Model: Mojito		Date: 10-Nov-00	No.: RA293015
Subject: Printer Controller (B337) System Firmware Histories		Prepared by: A. Sasaki	
From: Technical Service Dept., GTS Division			
Classification:	<input type="checkbox"/> Troubleshooting	<input type="checkbox"/> Part information	<input type="checkbox"/> Action required
	<input type="checkbox"/> Mechanical	<input type="checkbox"/> Electrical	<input type="checkbox"/> Service manual revision
	<input type="checkbox"/> Paper path	<input type="checkbox"/> Transmit/receive	<input type="checkbox"/> Retrofit information
	<input checked="" type="checkbox"/> Other (Information)

This is to inform about the modification histories of the system firmware of Printer Controller Type 700 (B337).

Model: Bellini		Date: 23-Aug-00	No.: RA294030
Subject: Interface Board Installation		Prepared by: A. Sasaki	
From: Technical Services Dept., GTS Division			
Classification:	<input checked="" type="checkbox"/> Troubleshooting	<input type="checkbox"/> Part information	<input type="checkbox"/> Action required
	<input type="checkbox"/> Mechanical	<input type="checkbox"/> Electrical	<input type="checkbox"/> Service manual revision
	<input type="checkbox"/> Paper p

SYMPTOM

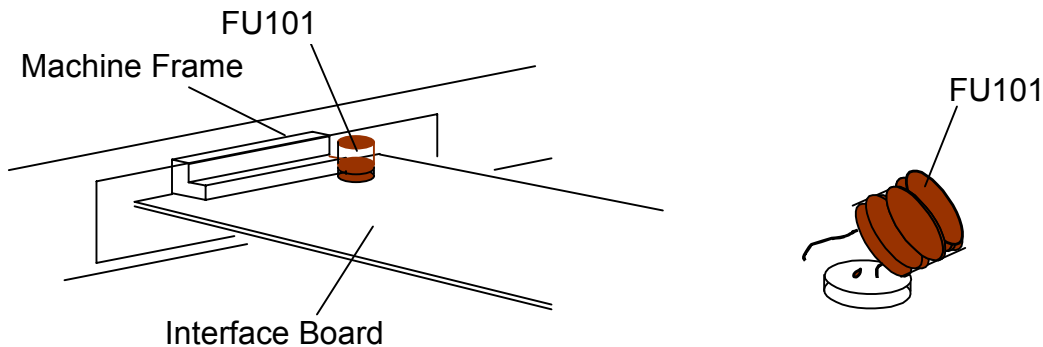
After inserting the interface board during installing any of the following optional equipment, the copier does not recognize them.

- Printer Controller
The printer feature menu in the user tools and SP mode does not appear on the operation screen.
- CD-RW
The CD-RW cannot be accessed in the Document Editor.
- Tandem Copy Kit
The “Copy Connect” key does not appear on the operation screen.

The fuse FU101 on the interface board is damaged.

When the interface board is inserted, the top part of the fuse brushes against the machine frame and a leg of the fuse comes loose.

Please make sure that the fuse on the interface board does not touch the machine frame when you insert the interface board.
